OHIO TURNPIKE COMMISSION

ADDENDUM NO. 1

CONTRACT NO. 59-13-05

PAVEMENT & DRAINAGE IMPROVEMENTS
SWANTON MAINTENANCE BUILDING, MILEPOST 48.3
FULTON COUNTY, OHIO

Plan Sheet 4 of 5

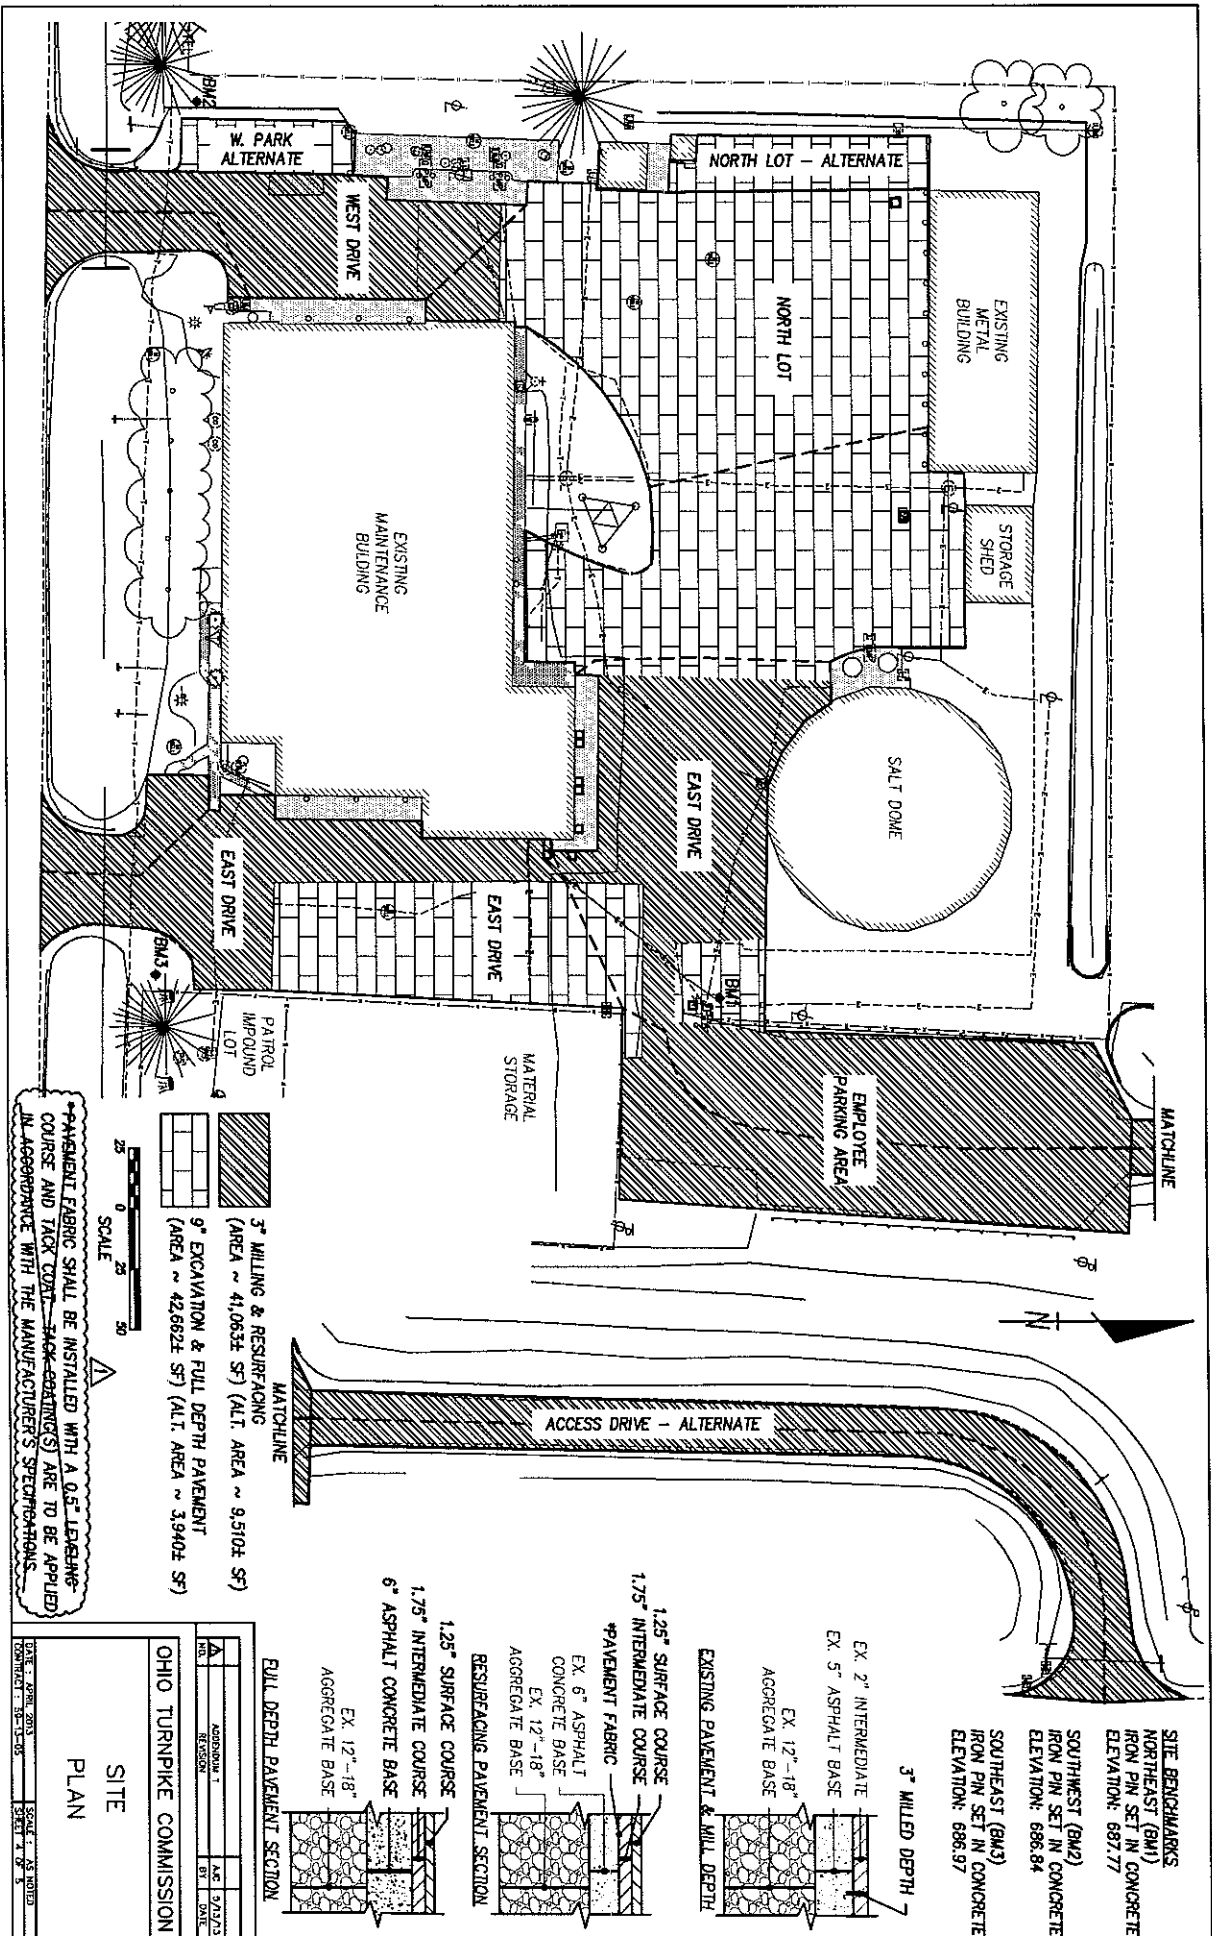
Q#1 The note on sheet 4/5 for pavement fabric states that the fabric shall be installed with a 0.5" leveling Course and tack coat. I do not see a pay item for the leveling course is the cost of this leveling course of asphalt to be included in the cost of the fabric? Also is this 0.5" accounted for in the final elevation of the parking lot, or should the milling depth be 3.5"?

Q#2 Sheet 4/5 has a plan note requiring a 0.5" leveling course to be installed with the pavement fabric. Is this leveling course to be installed prior to the placement of the pavement fabric and then the installation of the 1.75" Intermediate Course? If so, what specific asphalt mix is required for the leveling course.

The Note for "Removal and Replacement of Concrete Median" is deleted as follows:

~~* PAVEMENT FABRIC SHALL BE INSTALLED WITH A 0.5" LEVELING COURSE AND TACK COAT. TACK COATING(S) ARE TO BE APPLIED IN ACCORDANCE WITH THE MANUFACTURER'S SPECIFICATIONS.~~

A#1 The Note referenced on Plan Sheet 4 of 5 is deleted via this Addendum No. 1. No leveling course is required. However, the paving fabric shall be installed in accordance with the SP 629 and the General Note, and any asphalt concrete material required to repair any milled areas will be paid under the applicable asphalt concrete Bid Item.

A#2 See response to Q#1.
